CITY OF TEMPE DEVELOPMENT REVIEW COMMISSION

Meeting Date: 06/11/2019

ACTION: Request a Development Plan Review for a new 2,318 square foot restaurant with a drive through for CHIPOTLE STORE #3457, located at 1655 West Elliot Road. The applicant is SBL Engineering LLC. (PL190071)

Exterior Elevations - Color

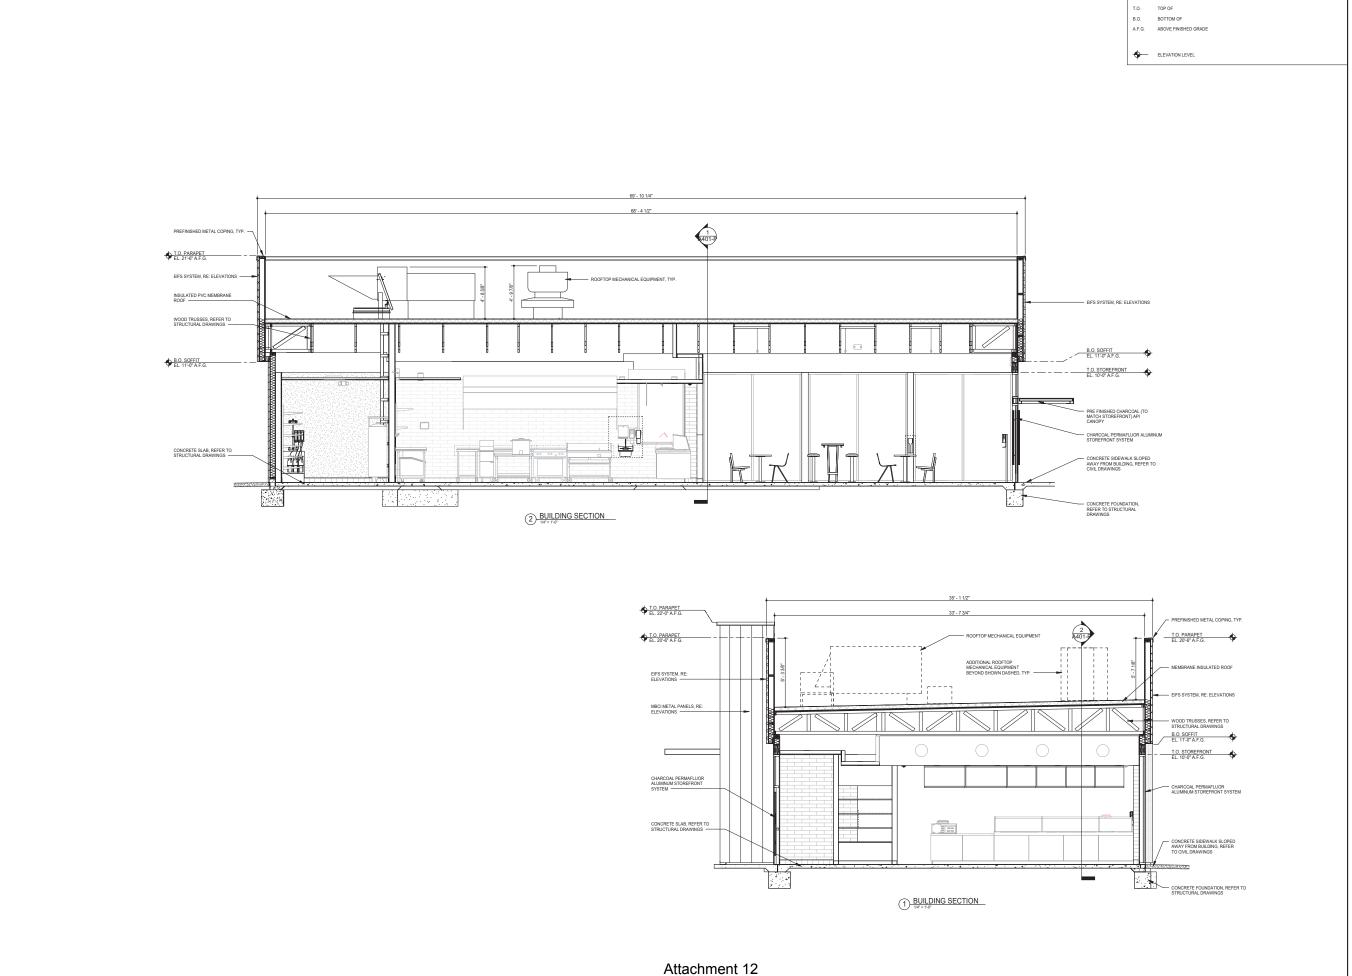
- 5. Staff recommended incorporating design elements from the south elevation on the north elevation to provide more architectural interest on the street frontage; *this comment was addressed on the revised plans.*
- 6. Staff recommended extending the tower element on the south elevation to make it more prevalent; *this comment was addressed on the revised plans.*
